WRITTEN STATEMENT OF CONDITIONS

The City of North Richland Hills received this plat on February 7, 2024. The Development Review Committee reviewed this plat on February 20, 2024. The following represents the written statement of the conditions for conditional approval of the plat. The applicant may submit a written response and revised plat that adequately addresses each condition.

PRELIMINARY PLAT

THE MEADOW

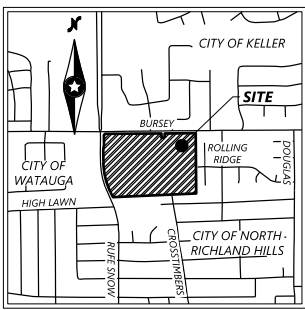
1. Revise the street name of the cul-de-sac in the adjacent Western Oaks subdivision to Sagebrush Court North. The street name for Sagebrush Court South may be added to the drawing. *NRH Subdivision Regulations §110-331 (Requirements for all plat drawings – street names)*

2. While street names are not necessary to show on the drawing, provide a list of street names being considered for the development. This will allow for review of the names to determine if there are any potential conflicts with other street names within the city. *NRH Subdivision Regulations §110-331 (Requirements for all plat drawings – street names)*

3. Label the 7.5-foot utility easement on all blocks. The label is missing on some blocks. *NRH Subdivision Regulations §110-331 (Requirements for all plat drawings – easements)*

4. Verify the width of Lot 8 Block D. The lot must be 60 feet wide at the building, but the lot scales at 59.2 feet. *NRH Subdivision Regulations §110-412 (Design criteria – lot dimensions)*

5. Add the following note to the plat: Above ground franchise utility appurtenances are not allowed in the fronts of the properties. *NRH Subdivision Regulations §110-331 (Requirements for all plat drawings – plat notes and conditions)*

6. Add the following note to the plat: The easements indicated on this plat are for the purpose of constructing, using, and maintaining public utilities including underground conduits, manholes, pipes, valves, posts, above ground cables, wires, or combinations thereof, together with the right of ingress and egress to operate and maintain the public utilities. *NRH Subdivision Regulations §110-331 (Requirements for all plat drawings – plat notes and conditions)*

7. The developer is required to construct masonry screening walls in specific locations as part of the public improvements. The required standard and locations are noted below, and a copy of the zoning exhibit is attached for reference. Provide a fencing plan with the next submittal of the public infrastructure plans. *NRH Ordinance 2742 §B.4*

8. A landscape plan for the open space lots must be included with the next submittal of the public infrastructure plans. The plan should also include the locations of the required large/canopy trees in open space lots, as noted below, and a copy of the zoning exhibit is attached for reference. The plan must be prepared by a registered landscape architect. *NRH Ordinance 2742 §B.9*

- ii. The remaining trees must be planted in internal open space lots within the development.
9. The existing sidewalk on Bursey Road must be replaced with a wider sidewalk as required by the Vision2030 Transportation Plan. The width of the sidewalk must be approved by the Development Review Committee. The proposed sidewalk design must be included with the next submittal of the public infrastructure plans. *NRH Ordinance 2742 §B.5.c*

10. The tree mitigation plan is not approved as part of the preliminary plat. Tree removal is not permitted until the plan is approved by the Development Review Committee. A plan was included with the plat submittal; however, some tree data is incomplete and still being collected by the applicant. The completed tree survey should be included with the next submittal of the public infrastructure plans. Trees proposed for removal may be subject to mitigation requirements depending on location, size, species, and planting of replacement trees. *NRH Code of Ordinances §114-33 (Trees - applicability of article provisions), §114-34 (Tree removal), and §114-35 (Tree replacement)*
